January 29, 2001

ZODIAC
CH601HD

HD WING SPAR SPLICE PLATES

KIT PART REPLACEMENT REQUEST FORM

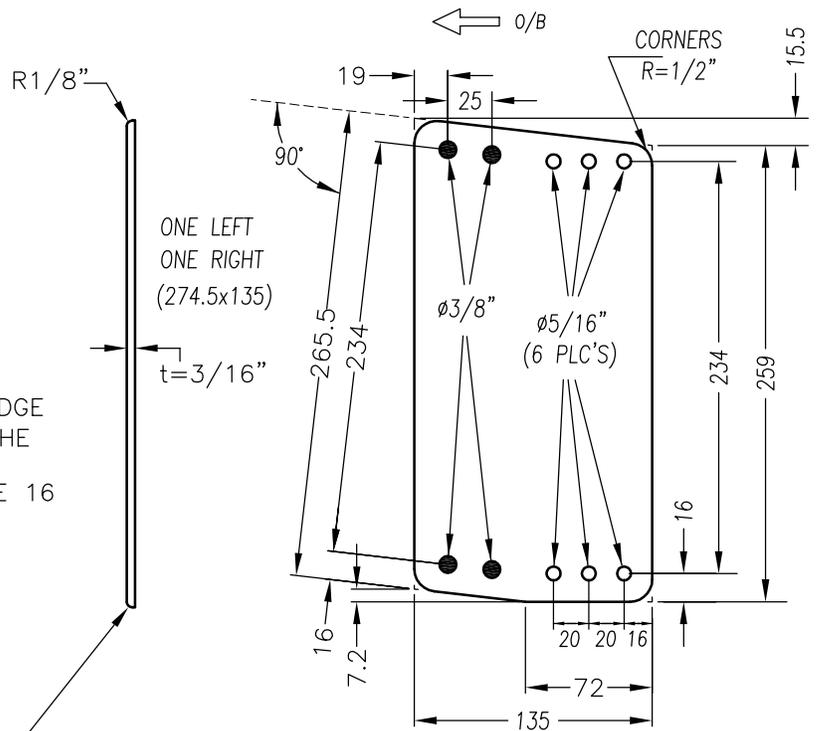
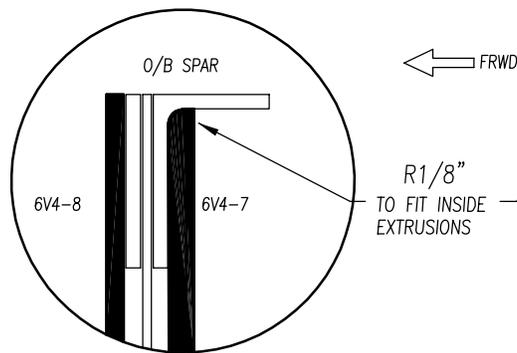
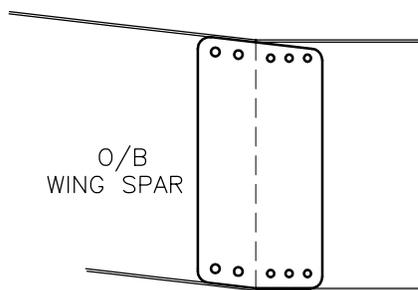
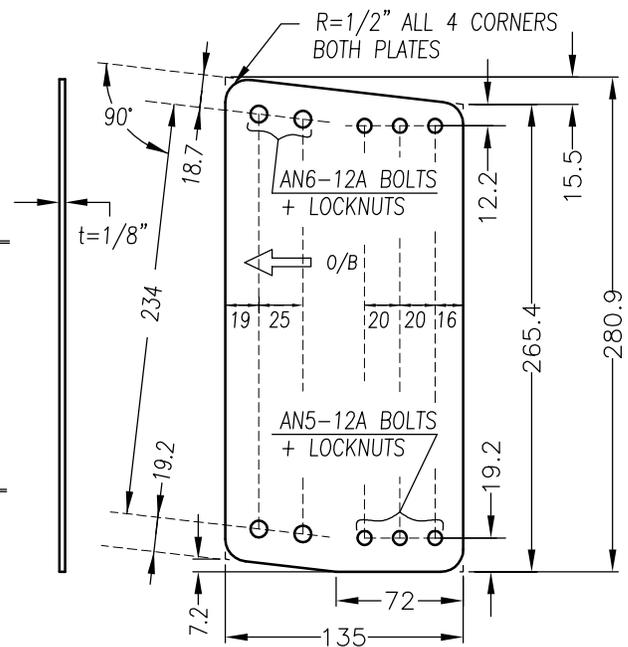
Upon inspection of several aircraft, it has come to my attention that some wing splice plates installed in ZODIAC aircraft do not meet the specifications shown on the Zodiac drawings, and that the design tolerance is not met. Check your wing spar splice plates, especially the rear plates, to verify that they are the correct size.

If the size of the splice plates is smaller than the dimensions specified on the drawings, and/or the edge distance of the holes is less than specified, the structural integrity of your aircraft will be affected. While I'm not aware of any spar splice plate failures, take the time to check your splice plates and replace them if required. If the spar splice plates do not meet the specifications the load capabilities of the aircraft (G loads) are diminished, and the fatigue life of the aircraft is reduced.

MINIMUM ACCEPTABLE: 10.0mm

DISTANCE "d" IS MEASURED FROM THE EDGE OF THE 3/8" HOLES TO THE EDGE OF THE PLATES 6V4-7, 6V4-7HD AND 6V4-8.
REFERENCE: CONSTRUCTION MANUAL PAGE 16

CHECK 1: THE SIZE OF THE PLATES; THE REAR PLATE 6V4-7 JUST FITS INSIDE THE OUTBOARD WING SPAR. THE TOP AND BOTTOM EDGES ARE PARALLEL WITH THE SIDES OF THE SPAR (FRONT & REAR PLATES)

CHECK 2: MEASURE "d" ON THE FRONT AND REAR PLATES TO THE EDGE OF THE EIGHT 3/8" HOLES: TWO UPPER, TWO LOWER - LEFT AND RIGHT SIDES.

CHECK 3: MEASURE THE DISTANCE "d" FROM THE EDGE OF THE 3/8" HOLES DRILLED IN THE OUTBOARD SPAR TO THE INSIDE EDGE OF THE SPAR EXTRUSION.

If you find that your splice plate(s) do not meet the specifications, replace them with new splice plates. Zenith Aircraft Company will send you replacement splice plates (free of charge). Use the attached form to request replacements. The new splice plates will need to be drilled, and will be shipped with instructions.

REPLACEMENT PLATES: USE 4130N t=1/8" WHEN THE DISTANCE "d" FALLS WITHIN THE RANGE OF 6mm TO 9.9mm (THE LOCATION OF THE 3/8" HOLES DRILLED IN THE OUTBOARD SPAR CAUSES "d" TO BE LESS THAN 10mm.) STAY WITH 6061-T6 IF "d"=10 OR GREATER.

NOTE: SAME LAYOUT AS 6V4-7 BUT BIGGER ON TOP AND BOTTOM BY 3.2mm REFERENCE: DRWG 6-V-4
